MINUTES
ALTOONA CITY PLANNING COMMISSION

Tuesday, January 7, 2020

**ALTOONA METRO TRANSIT – 3301 5TH AVENUE
 NEW STORAGE GARAGE PROJECT
 LAND DEVELOPMENT PLAN REVIEW**

Drawing No.
LP-1

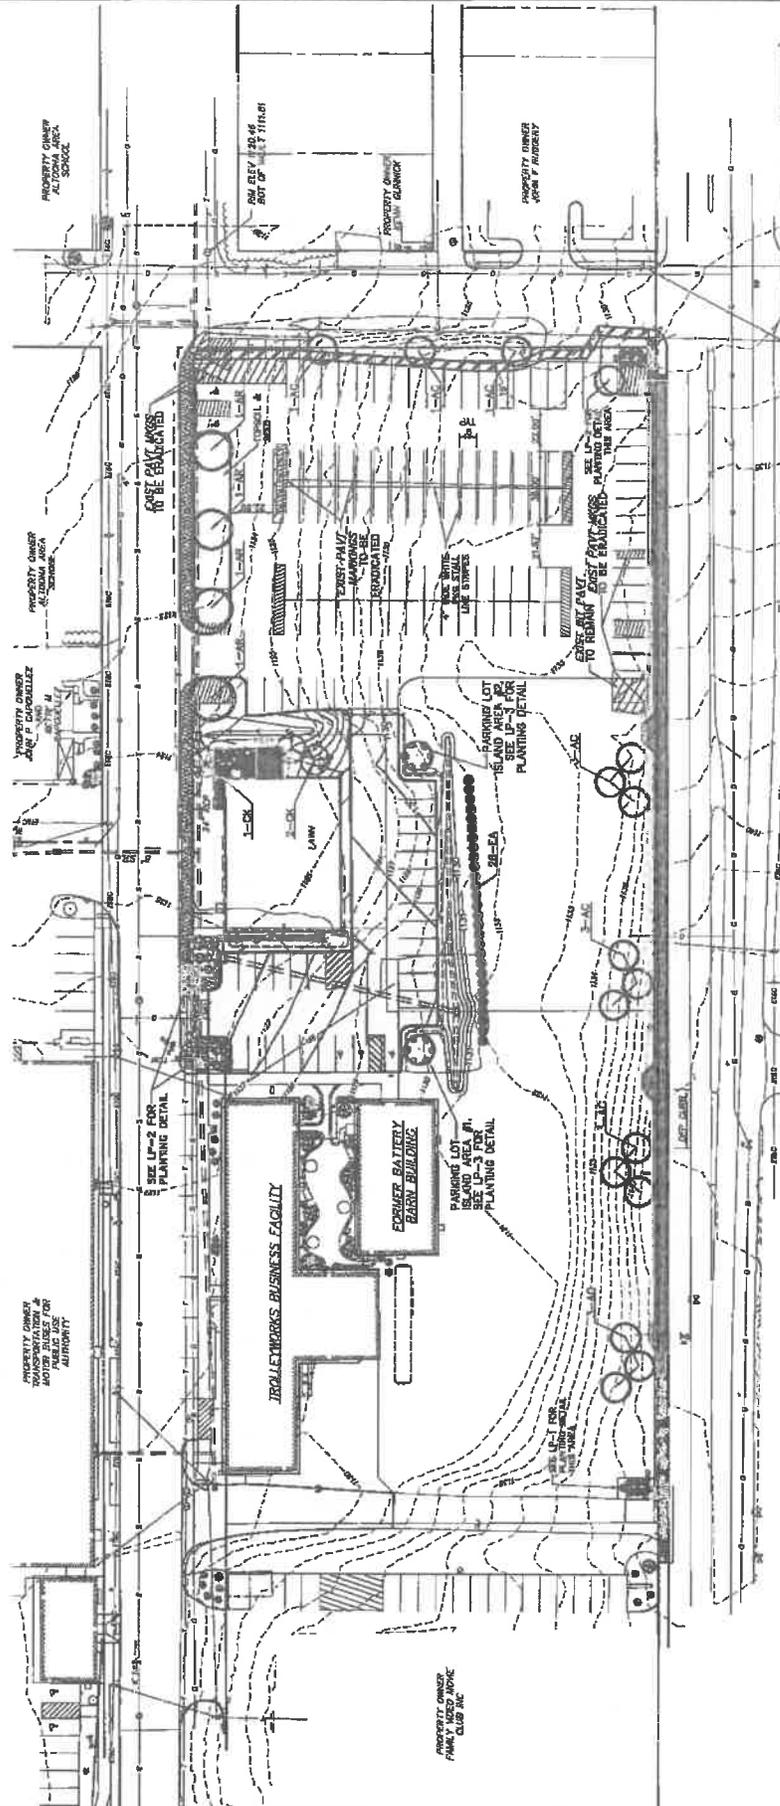
- There appears to be 2 trees shown on Sheet C-2 in the islands around the new parking area; however, they do not appear to provide any trees in the two islands closer to 5th Ave for the new parking lot. Additionally none of the 6 shrubs per tree appear to be provided. There also appears to be an at grade paved island near the northwest corner of the New Storage Building. No waiver was requested for any of these discrepancies. Additionally please show all landscaping on the Planting Plans so none get missed.

- > There appears to be 2 trees shown on Sheet C-2 in the islands around the new parking area; however, they do not appear to provide any trees in the two islands closer to 5th Ave for the new parking lot. Additionally none of the 6 shrubs per tree appear to be provided. There also appears to be an at grade paved island near the northwest corner of the New Storage Building. No waiver was requested for any of these discrepancies. Additionally please show all landscaping on the Planting Plans so none get missed. **Response: Shrubs have been added to all four (4) islands in the new parking lot. The Owner prefers to not add trees to the two islands along 5th Avenue due to the congestion of sidewalk and utilities within these areas and due to safety/sight distance. The Owner does not want the internal, at grade paved island in the new parking lot to be a raised island with curbing as it is unnecessary and would be a detriment to vehicular circulation and snow removal. A waiver is requested to not install the two (2) trees in the islands closest to 5th Avenue.**
